January 20, 2017
BOARD OF COUNTY COMMISSIONERS
ORANGE COUNTY, FLORIDA
Addendum No. 3 / IFB Y17-729-CC
East Orange Regional Park

1. Revision: The following “**East Orange County Park Multipurpose Field**” drawings have been revised and are attached:

OVERALL SITE DEVELOPMENT PLAN
EAST ORANGE COUNTY PARK MULTI-PURPOSE FIELDS
ORANGE COUNTY PARKS + RECREATION
 ORANGE COUNTY, FL

SITE DEVELOPMENT PLAN - ELECTRICAL

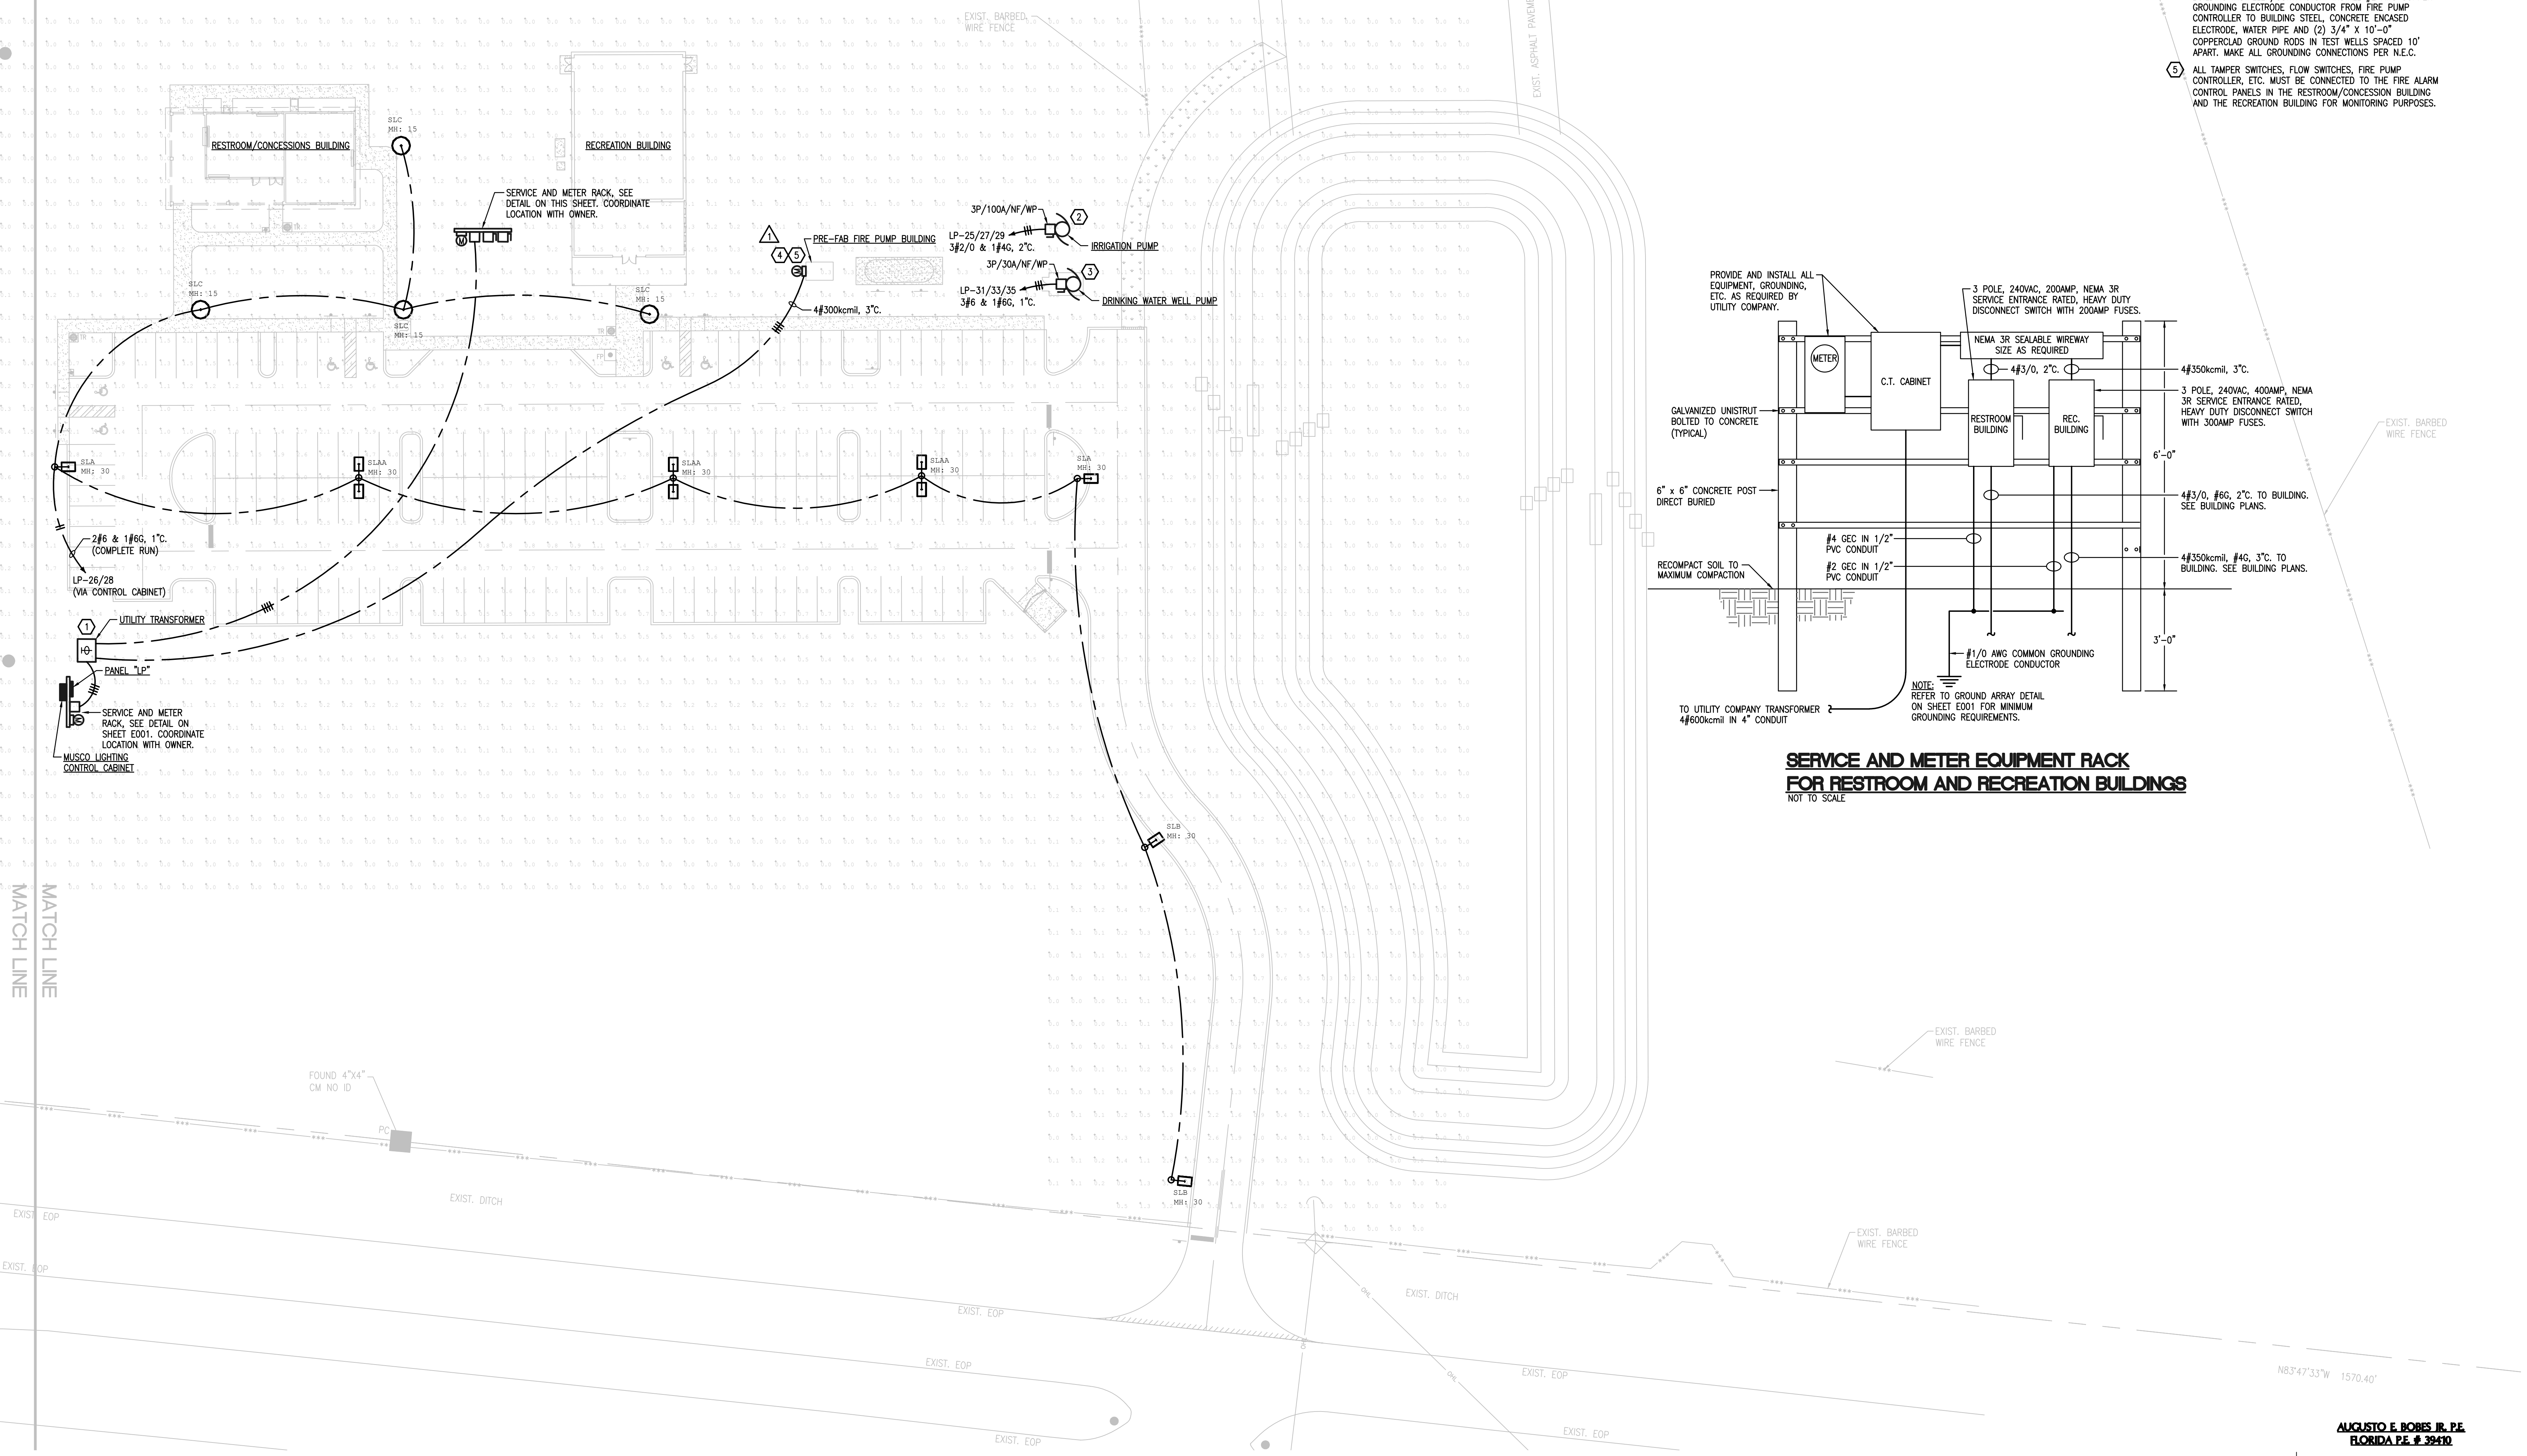
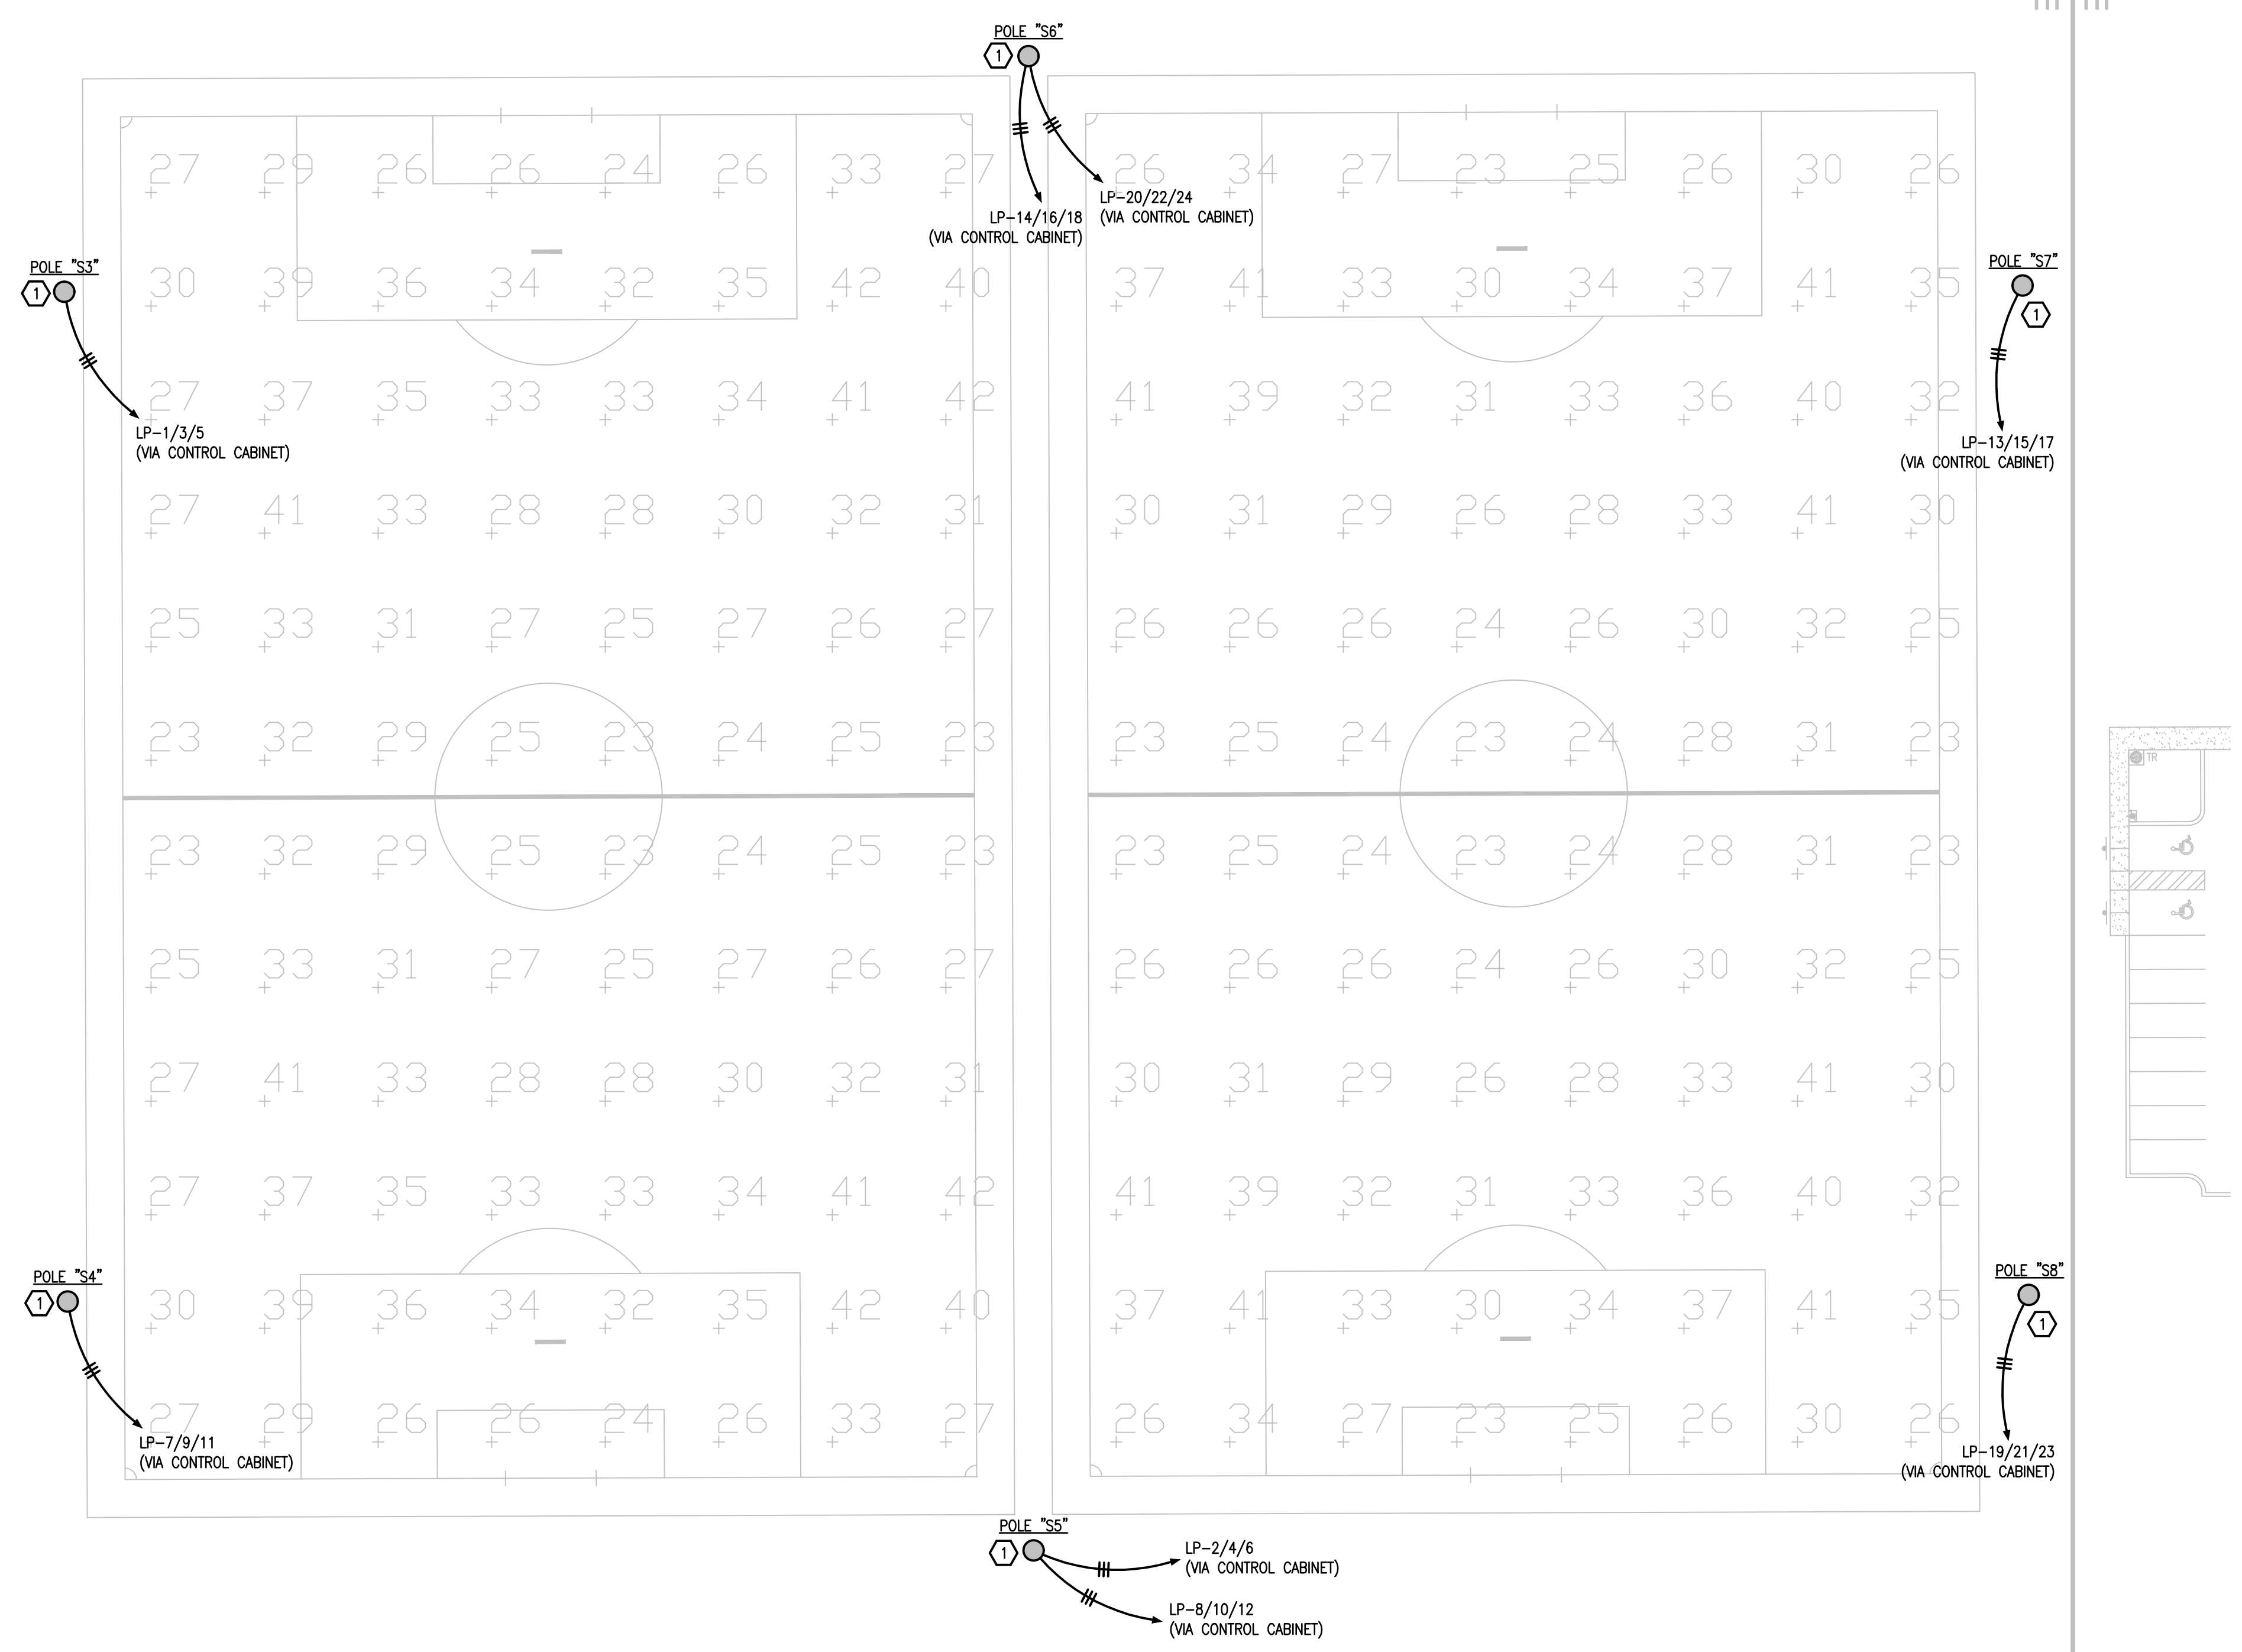
1. **Question (applies to the site drawings titled “East Orange County Park Multipurpose Field”)** On the Civil Drawings it calls out for New Light Poles LP around the Soccer Fields but the details/specs/plans are not provided. Please advise.

Answer: Site electrical and lighting plans are included in this addendum.
2. **Question (applies to the site drawings titled “East Orange County Park Multipurpose Field”)**: On the Civil Sheets it does not show any grass parking locations or details, but on A102 of the Recreation Building and sheet C100 of the Concession/Storage/Restroom Building it shows a grass parking area. Are we responsible for the Grass Parking Lot? If so please provide plans/details.
